THI QAR VILLAGE ROADS
SEGMENT 3
GOVERNORATE OF
THI QAR, IRAQ

SIGIR-PA-06-059
OCTOBER 26, 2006

SUBJECT: Report on Project Assessment of Thi-Qar Village Roads Segment 3 Project,
Thi-Qar, Iraq (Report Number SIGIR-PA-06-059)

Figure 2. Typical fill cross section

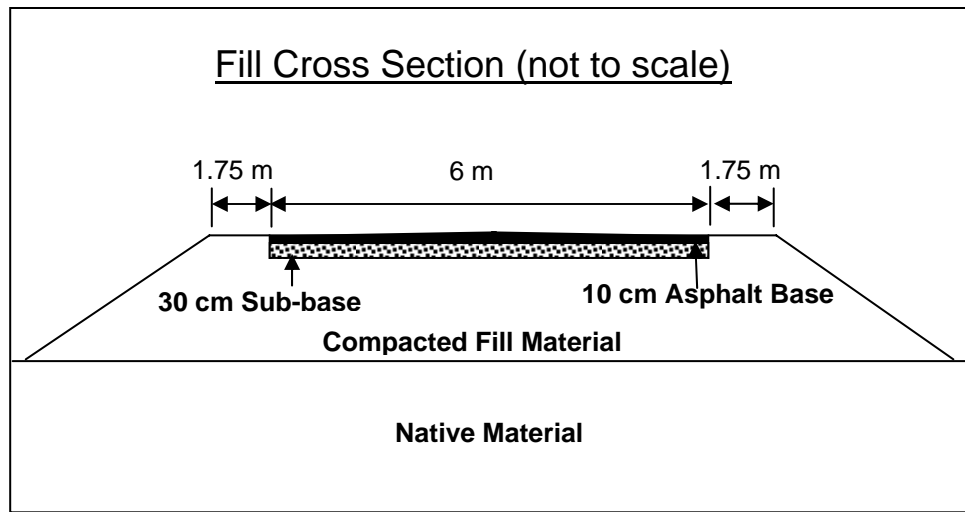
For an illustration of the typical fill cross section provided in the contract drawings, see Figure 2.

The BOQ required the contractor to place 95,000 m³ of fill material. Although, we were not able to verify quantities, we reviewed USACE Quality Assurance (QA) reports to determine the adequacy of the earthwork in constructing the fill sections along the 7.1 km roadway. Based on our review, the earthwork construction appeared to meet the requirements of the contract. The material stockpiled along the roadway prior to placement appeared capable of being compacted to form a stable fill area with side slopes as shown in Figure 2. Site Photos 1 and 2 show the material stockpiles used to construct fill sections. Site Photo 1 shows a dump truck placing material along the roadway. In Site Photo 2 a motor grader is leveling the material prior to compaction.
